Sub Regional RTEP Committee: Western AEP Supplemental Projects

May 21, 2021

Changes to Existing Supplemental Projects

Supplemental Project: S1851 (Need AEP-2018-AP001, posted to 2019 AEP local plan)

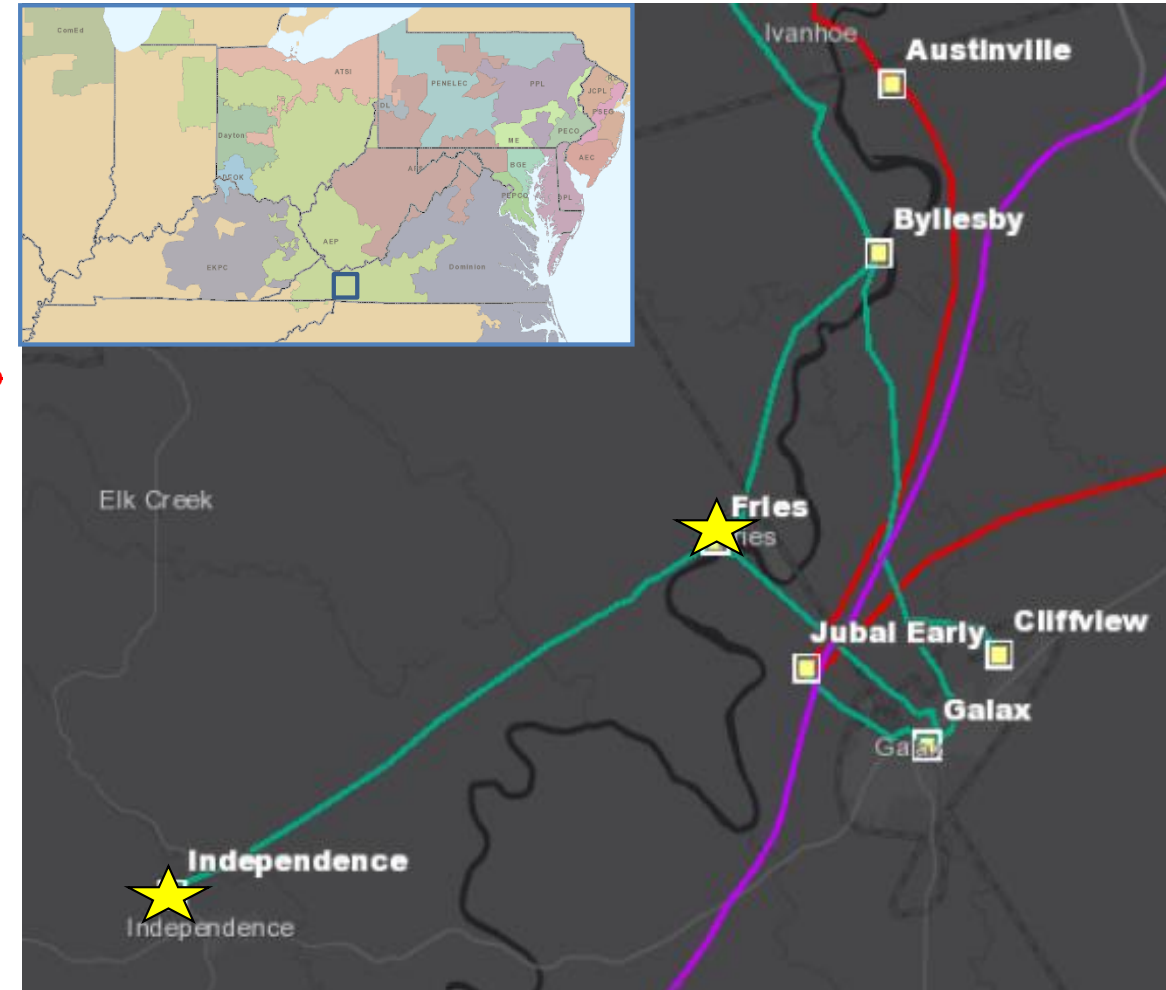
- Construct a new 69 kV line (approximately 14.25 miles) from Jubal Early Station to ~~Independence Point Lookout Station~~. Install a 69 kV circuit breaker at Jubal Early Station ~~and two 69 kV circuit breakers at Independence Station~~. The increased cost for the greenfield line is driven by an increase of rock and erosion control required for construction as well as access road along the new line route that was better defined as the scope was developed further.

Estimated Transmission Cost: ~~\$32.5M~~ \$42.7M (S1851)

- Relocate Independence Station to a new property and rebuilt as Point Lookout Station. Point Lookout Station will consist of a 69 kV bus, a 11.5 MVAR cap bank, two 69 kV circuit breakers. The station will also include a 69/34.5 kV 30 MVA transformer with two 34.5 kV distribution circuit breakers and a 69/12 kV 20 MVA transformer with one 12 kV distribution circuit breaker. The new cap bank at Point Lookout Station is replacing the existing cap bank at Fries Station due to the space limitations at Fries Station associated with remote end work. The cap bank at Fries Station can not be retired due to a voltage violation scenario and the new cap bank will maintain the voltages above our criteria thresholds. **Estimated Transmission Cost: \$0 (station is considered Distribution) (S1851.1)**

Reasons for the scope change: Due to the space restrictions at Independence Station, the station will be relocated to a new property.

New Projected IS Date: 6/1/2024

Supplemental Project: s1996 (Need AEP-2018-AP005, posted to 2019 local plan)

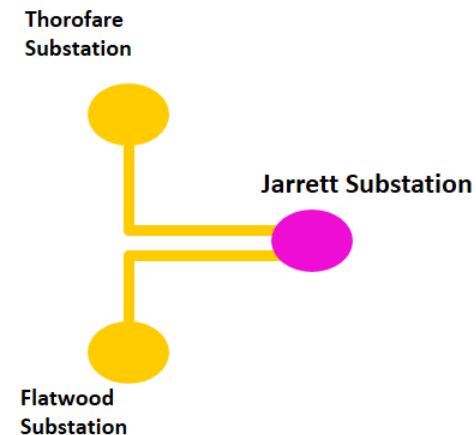
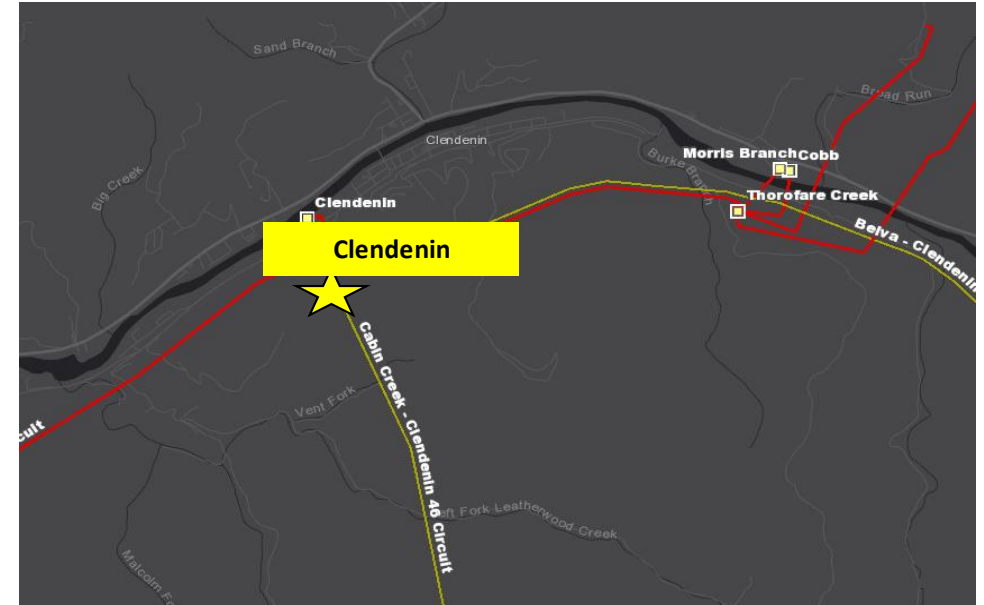
Replace the existing Clendenin Station with the new Jarrett Station, approximately ~~0.2~~ **0.1** miles away from Clendenin Station, located outside of the flood plain. Install a new 138/46 kV 90 MVA XFR, with a high side circuit switcher. Install two 138 kV 40 kA CBs and three 46 kV 40 kA CBs. Install a ~~9.6~~ **34.6** MVAR capacitor bank. Re-route the existing 138 kV and 46 kV transmission lines into the new station.

New Estimated Transmission Cost: ~~\$21.3M~~ \$21.2M (Note: cost does not include Distribution scope of work to install a new 138/34.5 kV 30 MVA transformer).

Reason for Revision: Prior to the 2020 RTEP window, preliminary analysis identified radial 715 criteria voltage violations on the following 138 kV buses: Jarrett (.83pu), Morris Branch (.83pu), Cobb (.83pu), Broad Run (.83pu), Thorofare S.S. (.83pu), and Ambler Ridge (.83pu) for the loss of Jarrett – Coco 138 kV (AEP_P1-2_#11225) and Ambler Ridge – Linden Road 138 kV (AEP_P1-2_#9102), which requires a larger cap bank to be installed. These are not considered baseline because the configuration change associated with the supplemental rebuild caused the violations; therefore, the cap bank size increase is supplemental.

New Projected IS Date: 3/15/2023
